# CLASS I SERVICE INSTRUCTIONS

No. 1065  
ATA Code 77-00

**SUBJECT:** ENGINE INDICATING - INSPECT THE ENGINE INSTRUMENT CLUSTER ASSEMBLY

**EFFECTIVITY:** BEECHCRAFT Duchess 76, serials ME-1 through ME-6 and ME-8 through ME-152.

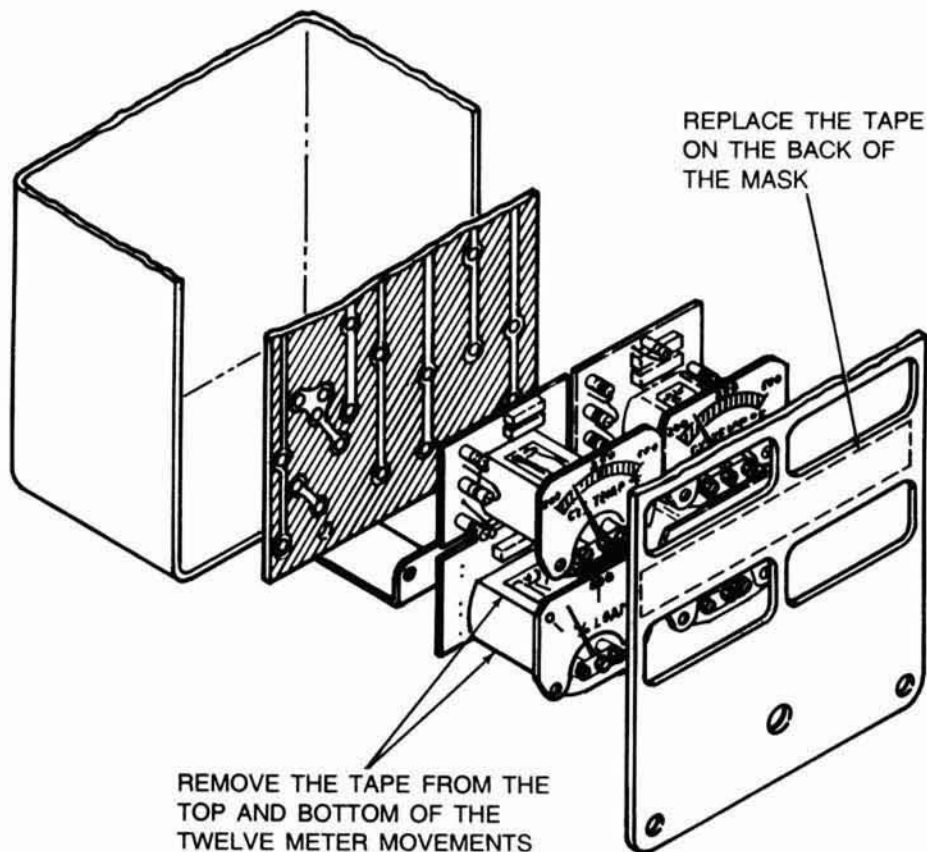
7. Using a small pair of tweezers, remove the yellow cellophane tape attached to the top and bottom of the twelve meter movements in the engine instrument cluster (see illustration). If it is necessary to remove an individual instrument to gain access to the meter movement, refer to the Duchess 76 Maintenance Manual, Chapter 77-00 to remove the instrument.

8. Remove the four screws attaching the engine instrument cluster mask to the supports and tilt the mask away from the engine instrument cluster to gain access to the back of the mask. Care should be taken not to damage the lights or wires which are attached to the mask.
9. Remove any yellow cellophane tape from the back of the mask and replace it with Scotch Brand Magic Transparent Tape No. 810 (obtain locally) (see illustration).

Do not use shiny cellophane tape, use only the frosted Scotch Brand Magic Transparent Tape.
